# Notice

### Information request

### Further information is required to assess an application for a site-specific environmental authority

The application reference number is: A-EA-NEW-100521948

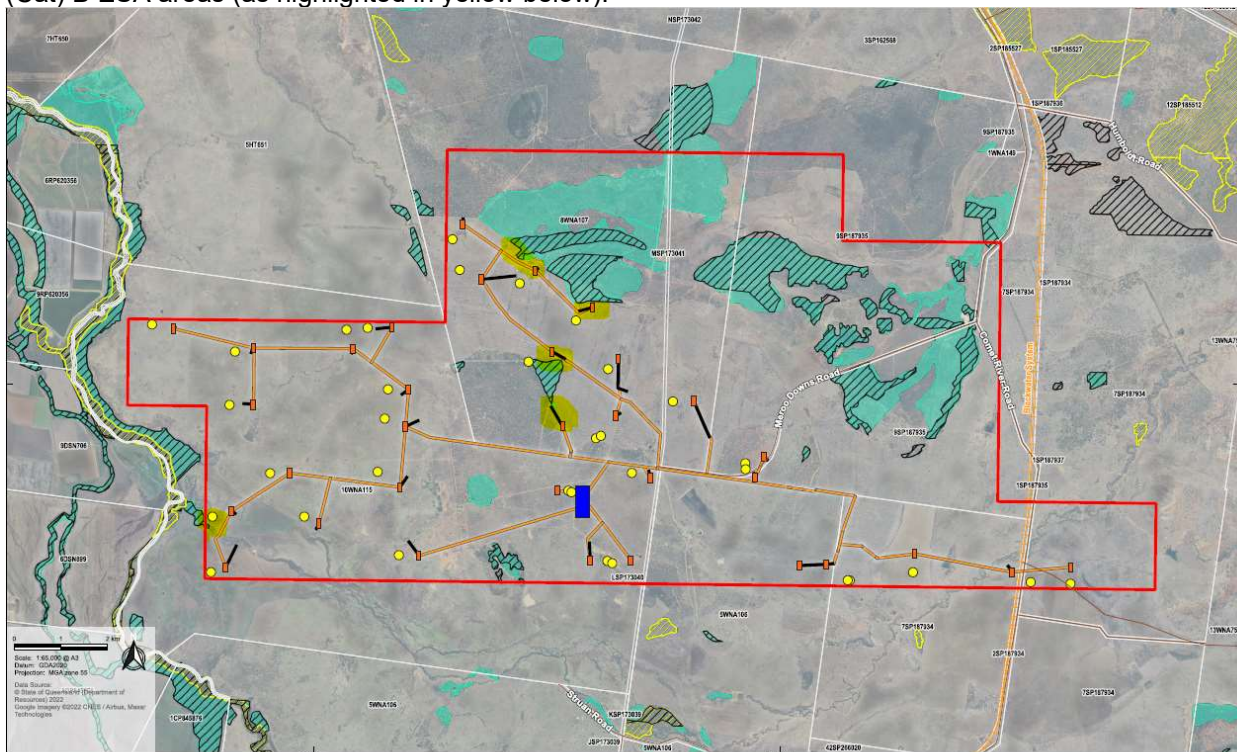
<p><b>HIGHLY PROTECTED ZONES OF STATE MARINE PARKS</b></p> <p>A highly protected area of a relevant Queensland marine park.</p>				
	<p><b>FISH HABITAT AREAS</b></p> <p>A declared fish habitat area – insert reference</p>				
	<p><b>WATERWAY PROVIDING FOR FISH PASSAGE</b></p> <p>Any part of a waterway (not in an urban area) providing for passage of fish – insert reference</p>				
	<p><b>MARINE PLANTS</b></p> <p>Marine plant (not in an urban area) – insert reference</p>				
	<p><b>LEGALLY SECURED OFFSET AREA</b></p> <p>Legally secured offset area – insert reference</p>				
10	<p><u>Issue</u></p> <p>The application material states that the project will not disturb Environmentally Sensitive Areas (ESAs) or their protection zones. However, Figure 14 ‘mapped environmentally sensitive areas’ of the ‘Supporting</p>

Information Report' depicts some indicative vertical wells and access tracks adjacent mapped Category (Cat) B ESA areas (as highlighted in yellow below).

1. Please confirm the buffer distances between the mapped Cat B ESA on Figure 14 and the adjacent proposed disturbance.
2. Should the proposed disturbance impact the primary or secondary protection zone, please quantify the extent to which disturbance impacts within ESAs and their associated protection zones using the below table. These impacts should be listed against each protection zone trigger (i.e. Category B, Category C, and for each listing of 'Essential Habitat' or 'Of Concern', etc.). If certainty cannot be provided, justification should be provided that outlines appropriate risk management strategies to avoid impacts.
